# LOWER MINNESOTA RIVER WATERSHED DISTRICT

Lower Minnesota River Watershed District Board of Managers Meeting  
Wednesday, June 15, 2022

#### Item 6. I. – LMRWD Permits and Project Reviews

**Re:** Core Crossings Apartments – Amendment (LMRWD No. 2021-020)

Figure 1: Core Crossings Apartments Project Location

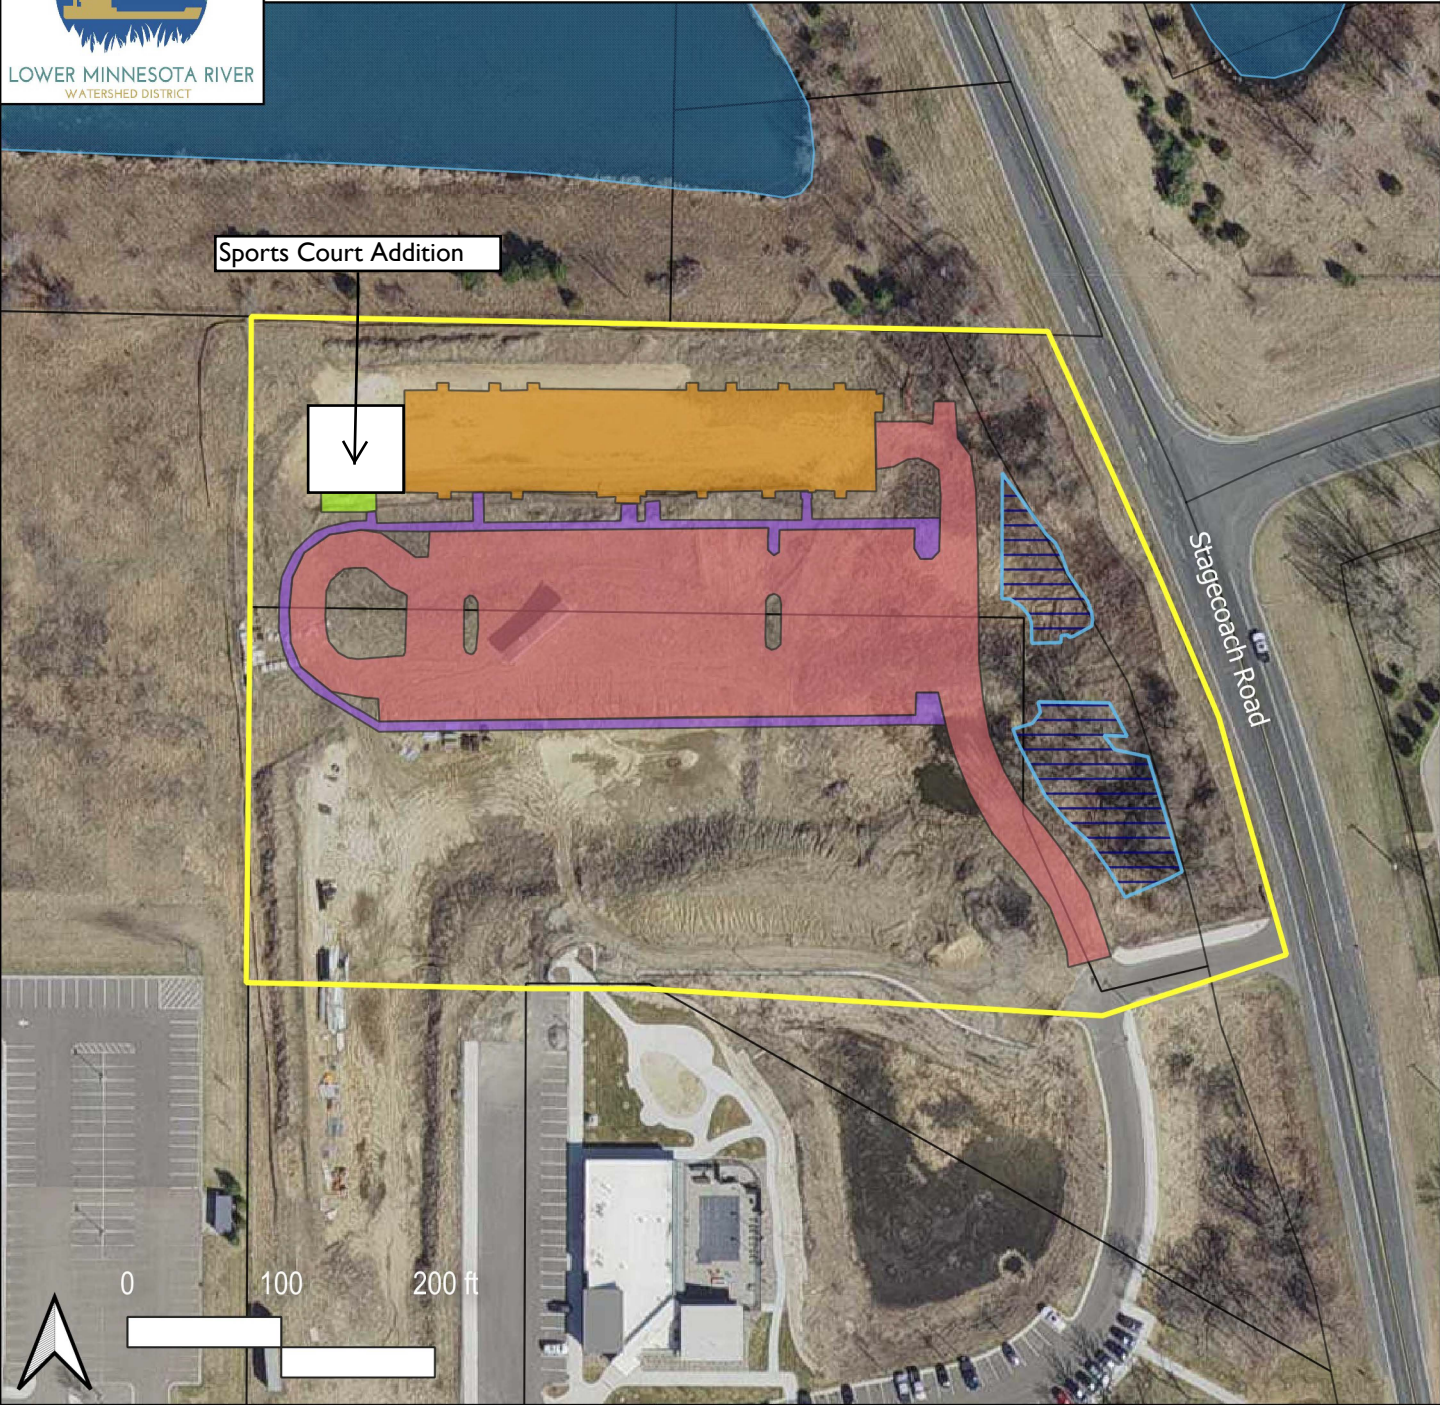
The applicant contacted the LMRWD to discuss renewal of the permit and an amendment to the original permit terms to include the addition of a small sports court (Figure 1).

<u>Project Name:</u>	Core Crossings Apartments Amendment
<u>Purpose:</u>	Sports court addition
<u>Project Size:</u>	1,886 square feet new impervious surface
<u>Location:</u>	1360 Stagecoach Road, Shakopee, MN 55379
<u>LMRWD Rules:</u>	Rule B – Erosion and Sediment Control Rule D – Stormwater Management
<u>Recommended Board Action:</u>	Approval

Staff recommends approval of the permit amendment and extension of the permit term to June 15, 2023.

Figure I: Core Crossings Apartments Project Location

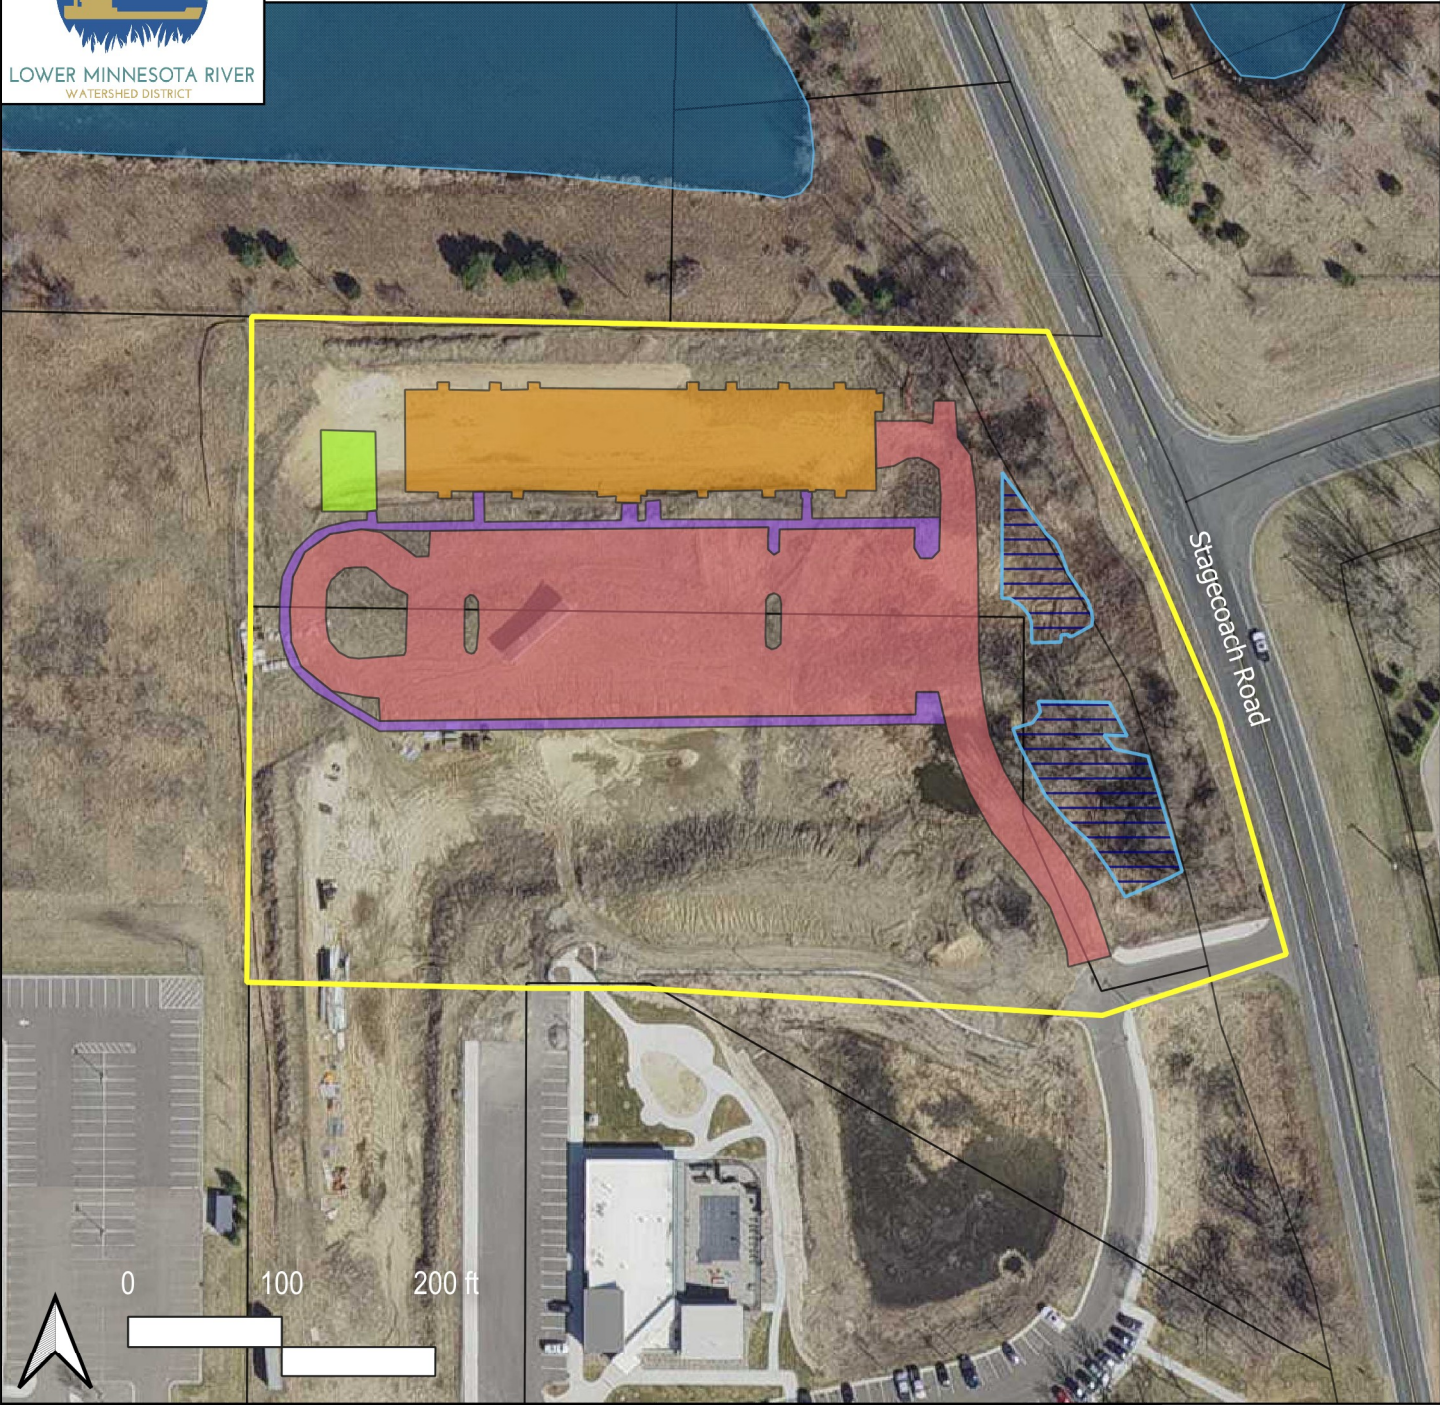
Sand Companies (the applicant) has applied for an individual project permit from the Lower Minnesota River Watershed District (LMRWD) to develop an apartment building in the City of Shakopee (City), as shown in Figure 1. The applicant's engineer, Larson Engineering, has provided site plans for the Core Crossings Apartments project (Project) along with the permit application. This Project was previously reviewed as part of the Wetland Conservation Act application by Young Environmental Consulting Group (Young Environmental) under the project name Southbridge Crossings; the wetland delineation was approved June 7, 2021.

The proposed Project consists of constructing an apartment building, playground, parking lot, sidewalks, and two infiltration basins (Figure 1). The Project would disturb approximately 3.8 acres and create 1.8 acres of new impervious surfaces. The Project is not located within the High Value Resource Area, Steep Slopes Overlay District, or within a 100-year floodplain, and the applicant proposes to commence construction on August 2, 2021. The Project is part of a second phase of the two-phase development. The first phase consisted of several apartment buildings, two parking lots, and two infiltration basins.

Staff recommends conditional approval of the Project, pending receipt of the NPDES permit copy and contact information for the contractors. The City of Shakopee must also provide the final copy of the executed Utility Facilities Agreement after it has been recorded with Scott County.

Figure I: MN MASH Project Location

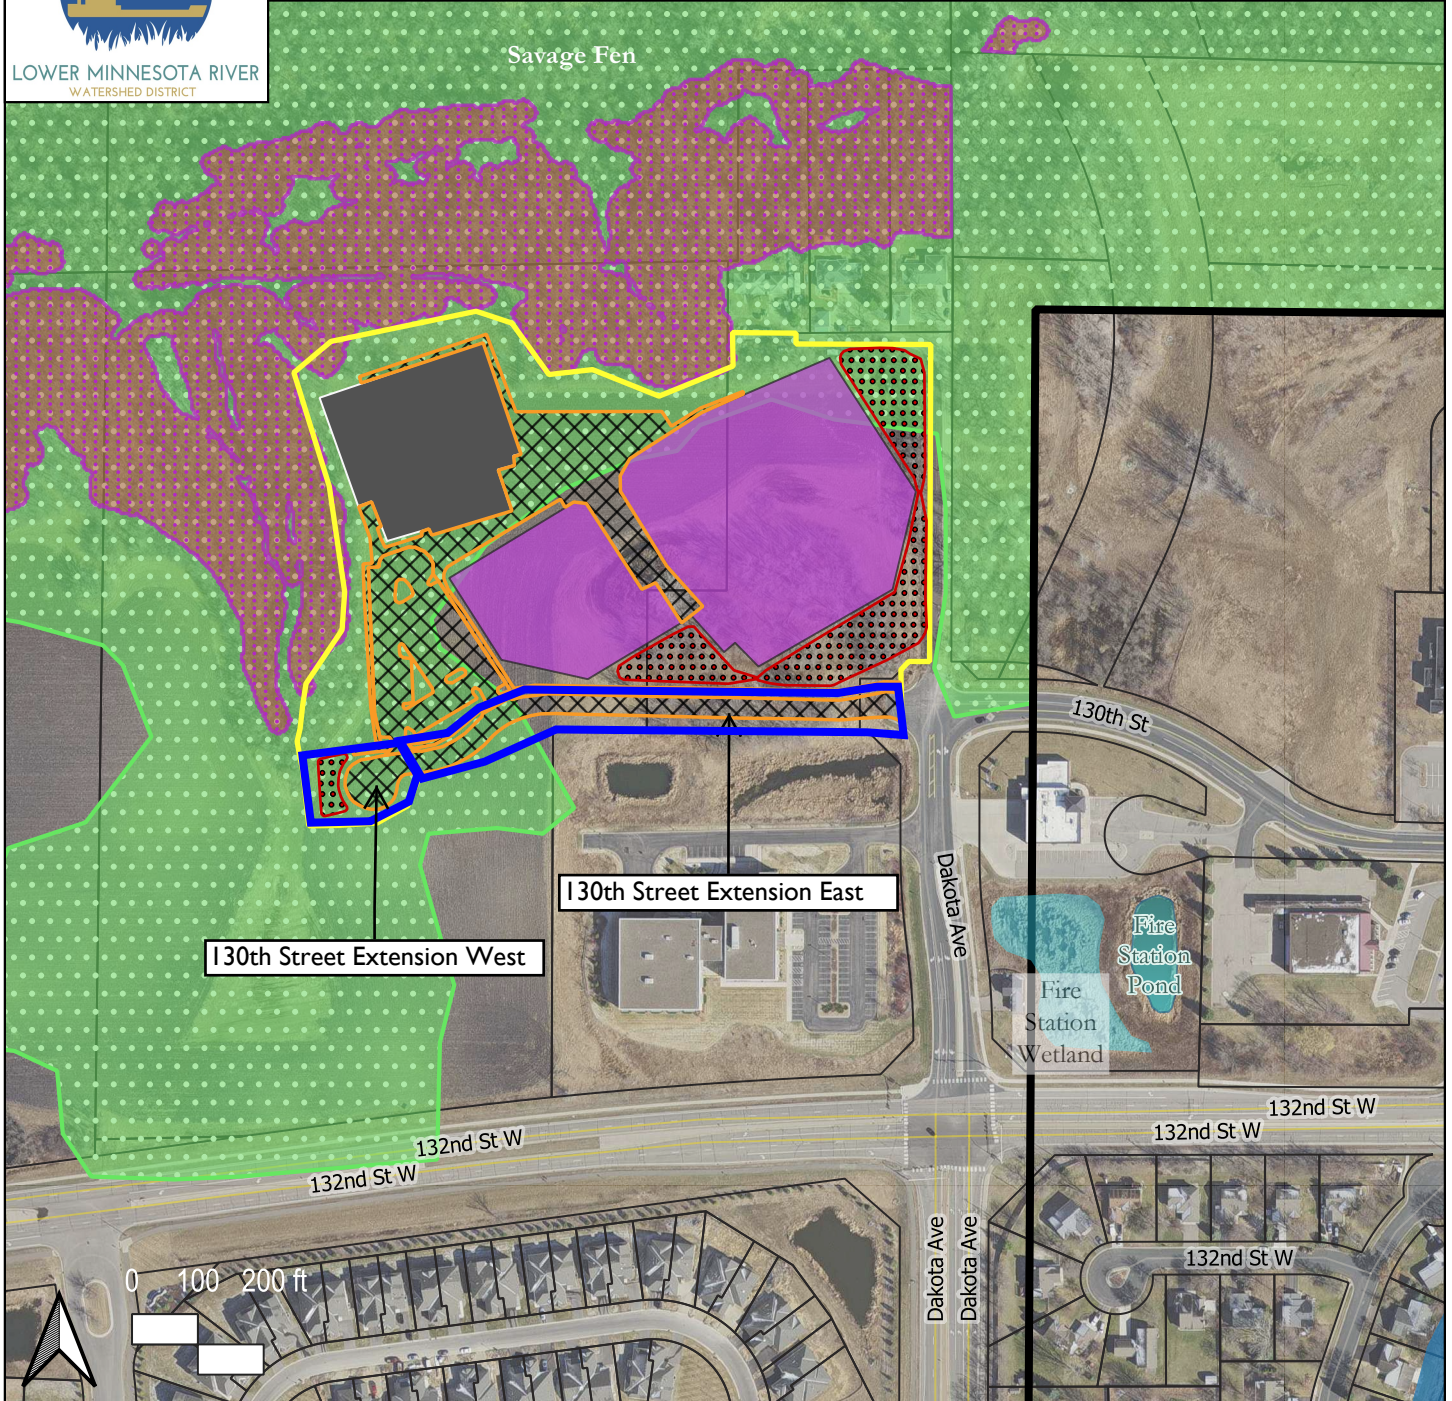
The 130th Street East extension is treated by Fire Station Pond. Adjacent to the pond is the Fire Station Wetland, as shown in Figure 1. The pond discharges to the wetland through an outlet control structure, and the wetland discharges to the City storm sewer. The City proposes to modify the existing outlet structure of the pond by raising the weir elevation to 897.2 to reduce outflows. The peak runoff rates were evaluated at the outlet of the wetland to determine downstream effects (Table 3). There is a 0.01 cfs increase for the two- and 10-year event due to the minimum four-inch diameter orifice requirement by the City. Staff concurs with the City that a decrease in peak runoff rates for the 100-year event outweighs the negligible increases.

With the proposed modifications to the City Fire Station Pond demonstrating the Project now meets the requirements of Rule D, staff recommends full approval of the project.

Figure I: CenterPoint Oak Street North

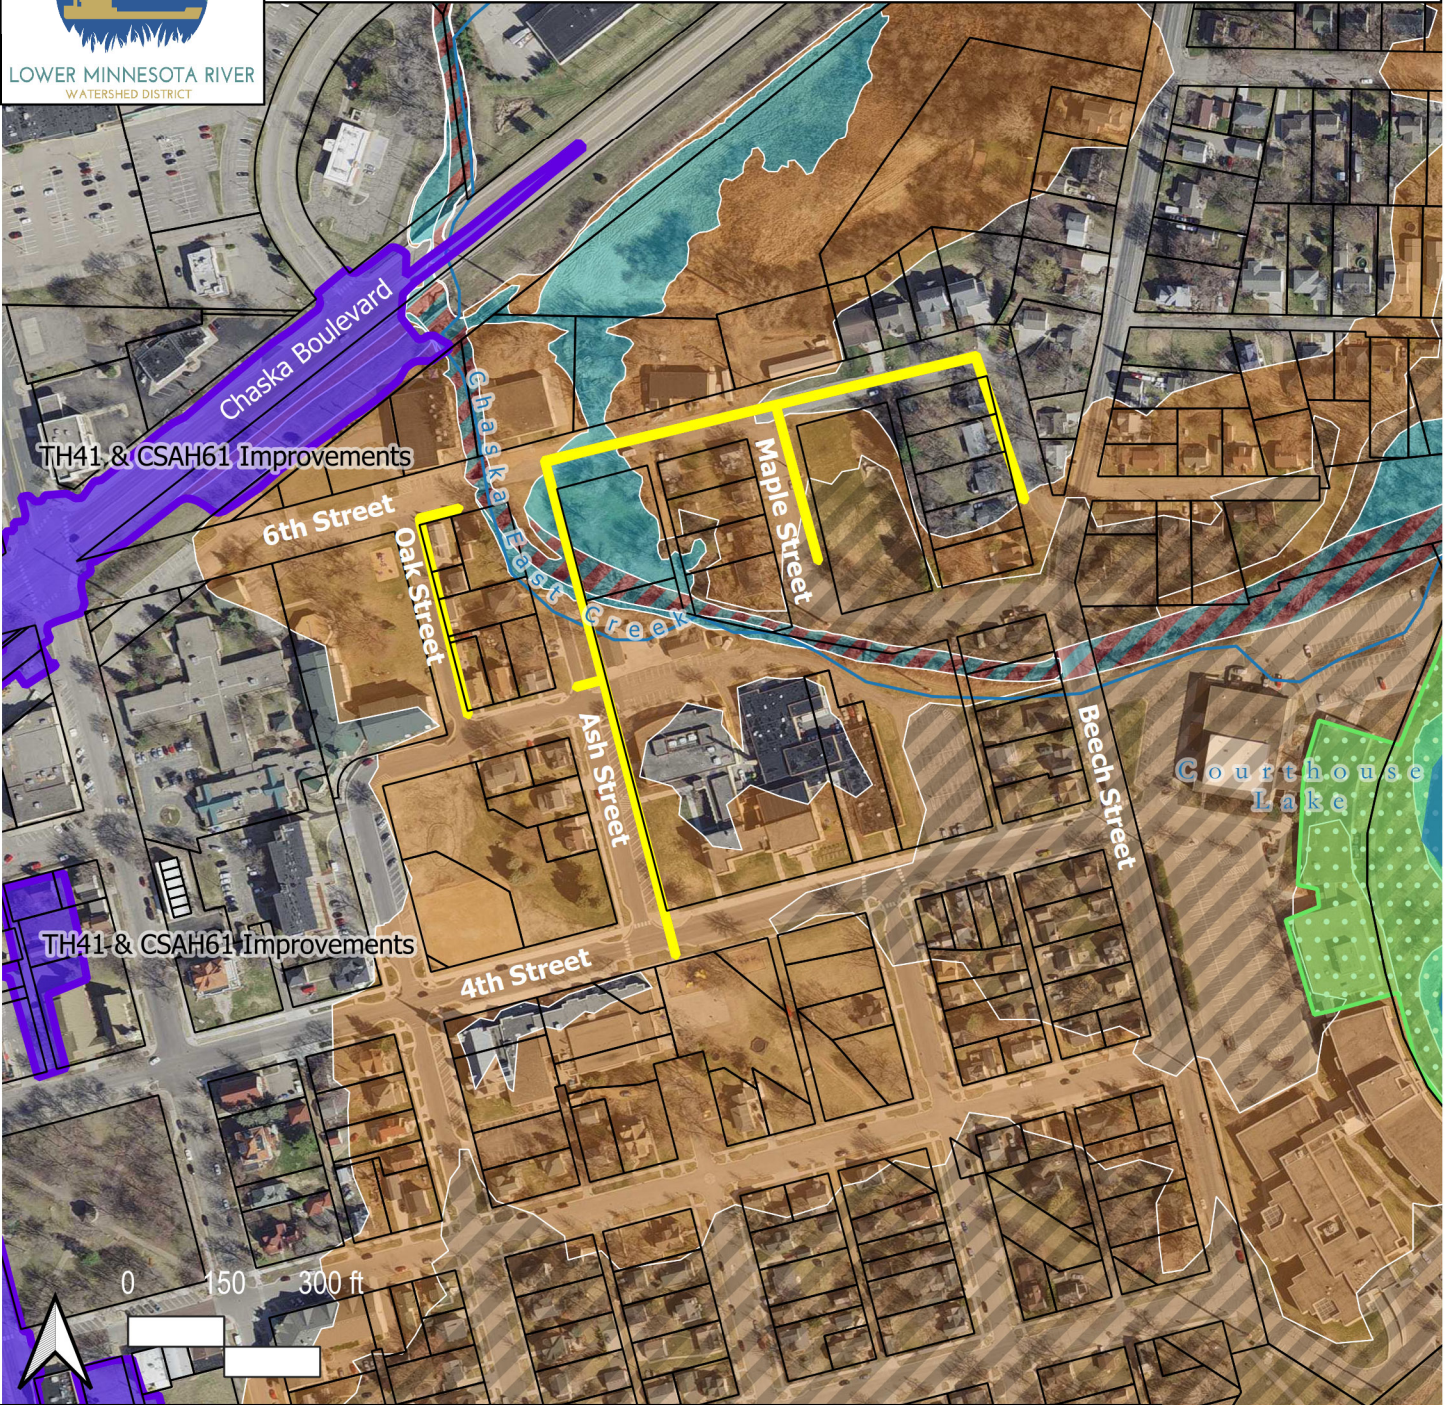
CenterPoint Energy (the applicant) has applied for an individual project permit from the Lower Minnesota River Watershed District (LMRWD) to construct approximately 2,100 linear feet of natural gas pipeline (the Project) under East Chaska Creek in the City of Chaska (City), as shown in Figure 1. The applicant's engineer, Merjent Engineering, has provided site plans for the Project along with the permit application.

Staff recommends approval of the Project.
